STAFF FINDINGS:

I move that the Commission issue a certificate of appropriateness for the application at 548 South First Street, a contributing property in the Old West Side Historic District, to add 199 square foot rear addition. As proposed, the work is compatible in exterior design, arrangement, texture, material and relationship to the rest of the building and the surrounding area and meets *The Secretary of the Interior's Standards for Rehabilitation and Guidelines for Rehabilitating Historic Buildings*, in particular standards 2, 5, 9, and 10 and the guidelines for building site, additions and roofs, as well as the *Ann Arbor Historic District Design Guidelines* for all additions, residential additions, and roofs.

Johnson Residence

- Addition -
548 S. 1st Street
Ann Arbor, MI 48103

PROPOSED SITE PLAN

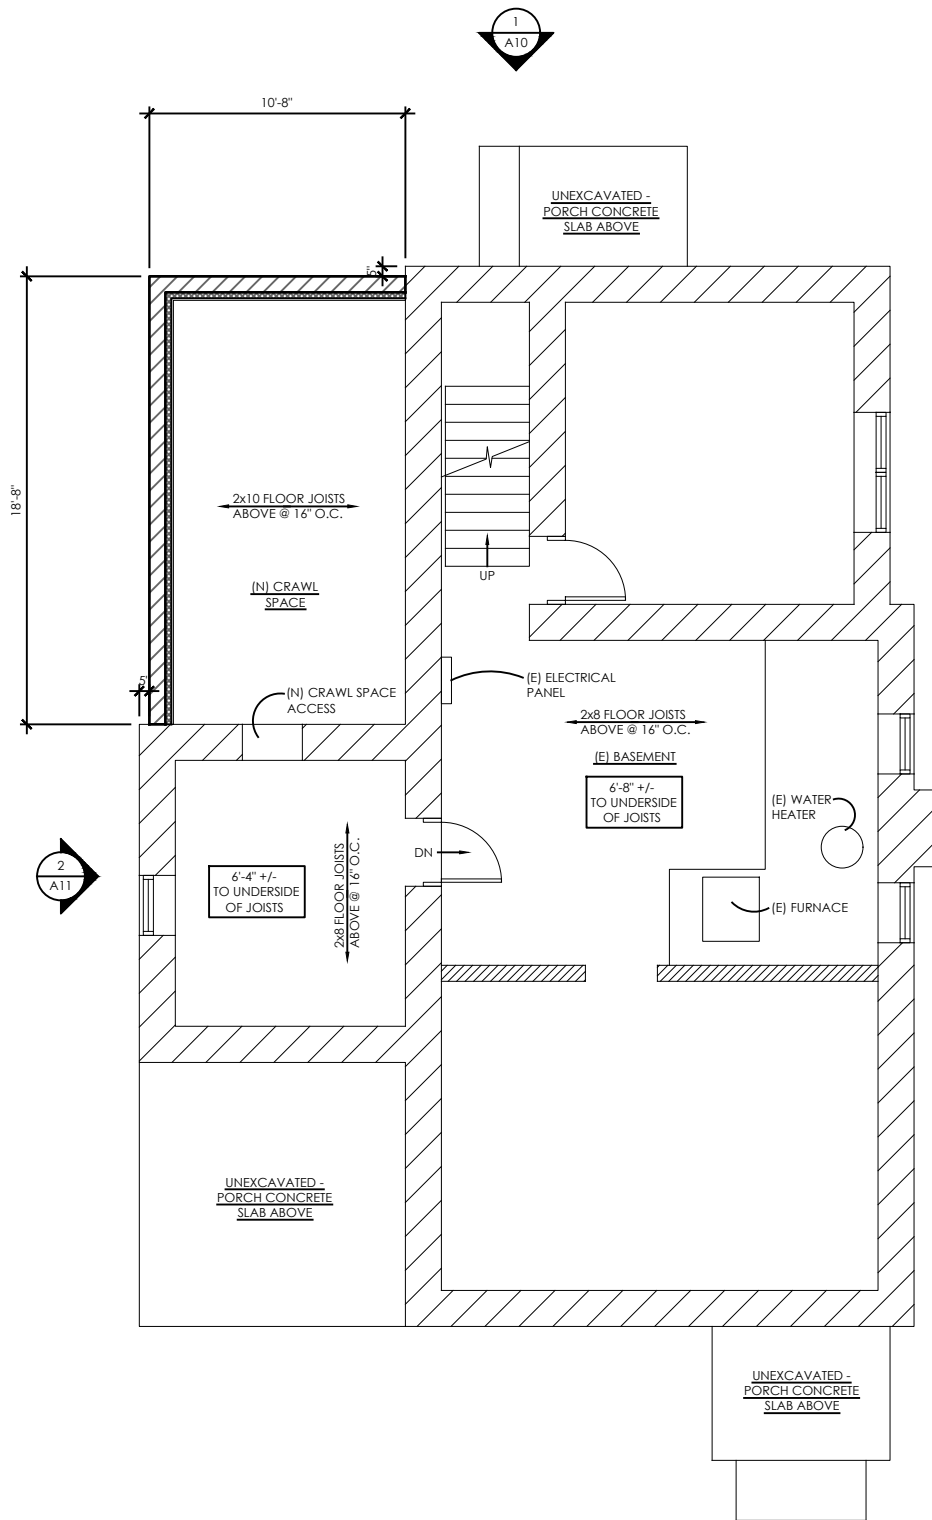
2. The house is currently 1,794 square feet (not including the basement) per the City Assessor. All of this floor area is believed to have built before 1945. The proposed addition adds 199 square feet, for an increase of 11%. The Assessor lists the footprint as 1,164 square feet, so the addition would be an increase of 17%.

PROPOSED FIRST FLOOR PLAN

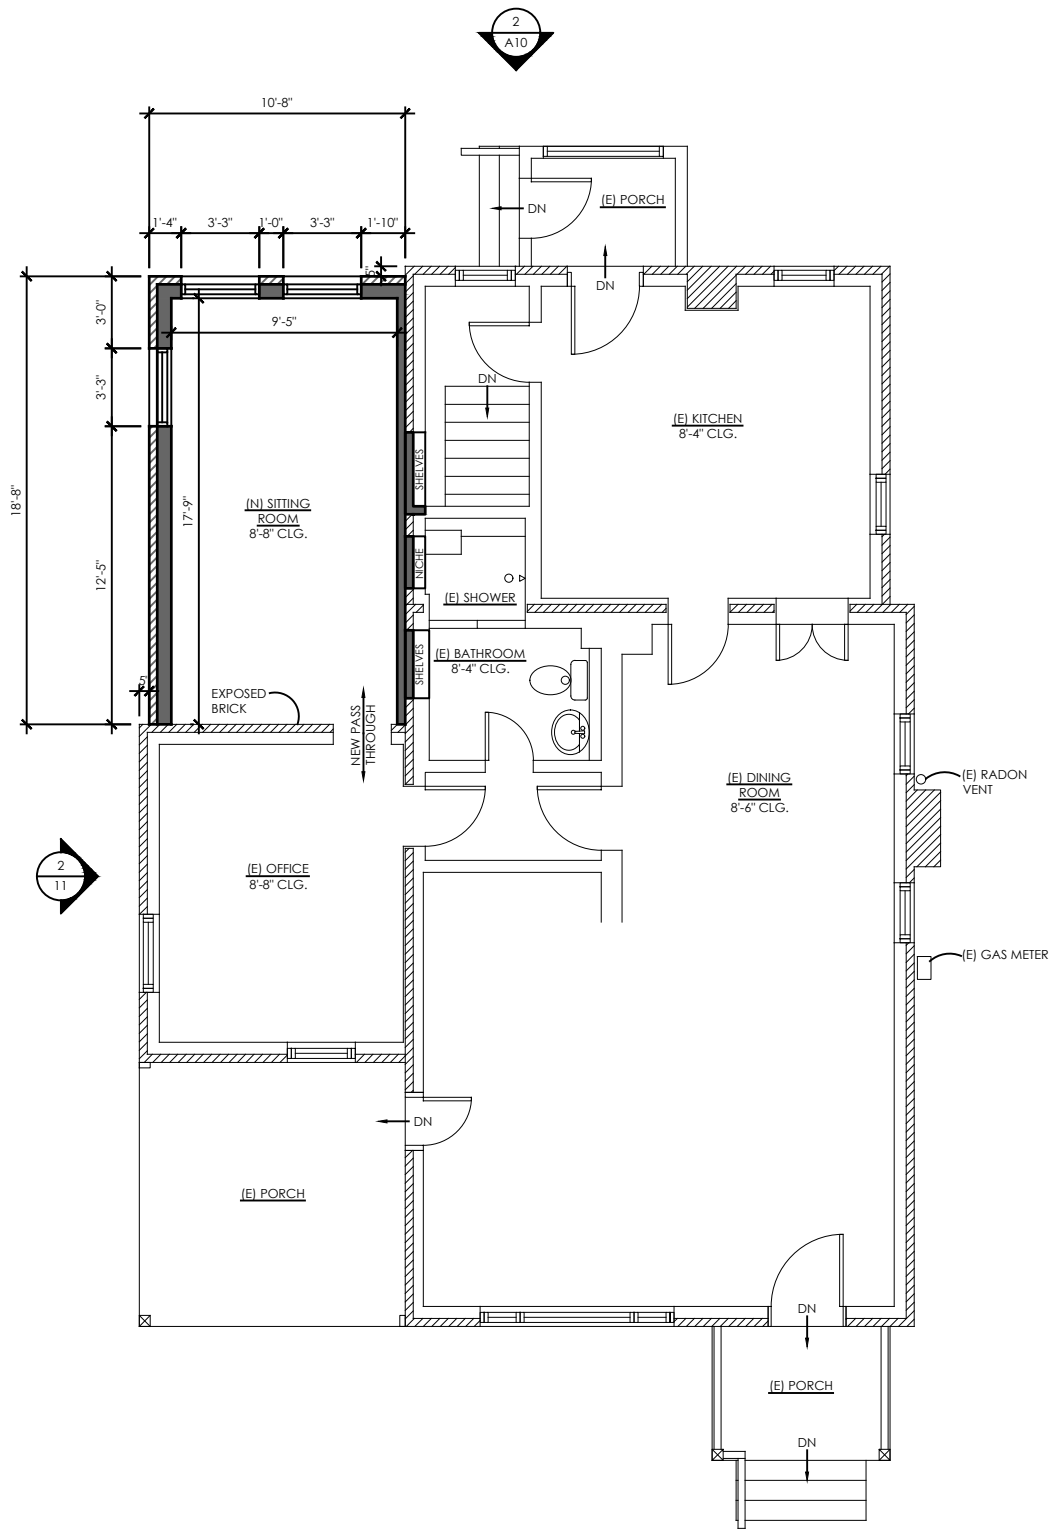
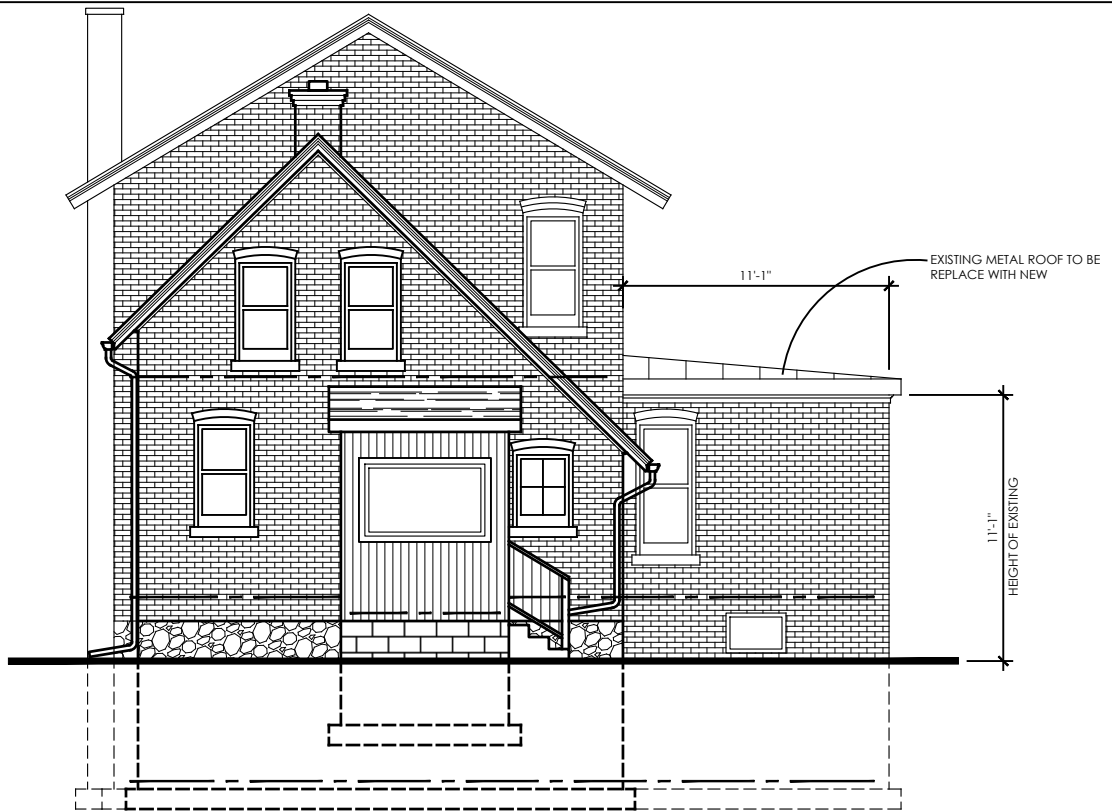
1. The 199 square foot addition would infill a space between the side wing and the rear addition. The addition is inset 5" from the existing corners of the house. It continues the plane of the roof that current covers the front screen porch and side wing to the back of the house. Two historic wood windows and a glass block window would be lost to the addition.

2 PROPOSED WEST ELEVATION

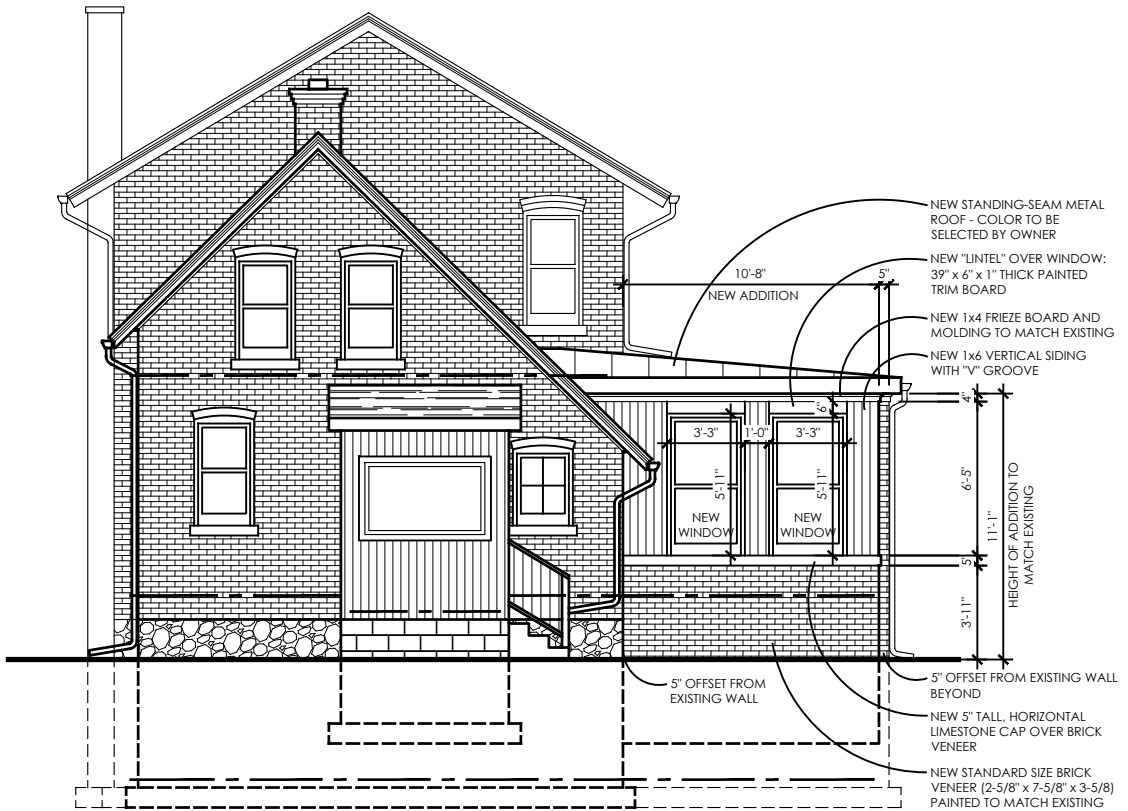
3. The addition's cladding is standard size brick veneer on the bottom 4', below 6" vertical TruExterior poly ash. Per their website, TruExterior products are made of fly-ash (a coal combustion by-product) combined with polymers. New windows on the addition are Jeld-Wen wood double-hung. They are 2" shorter than other first floor windows on the south elevation. The windows have a false "lintel" made from a painted 6" trim board on edge. Like the existing, the roof will be standing seam metal.
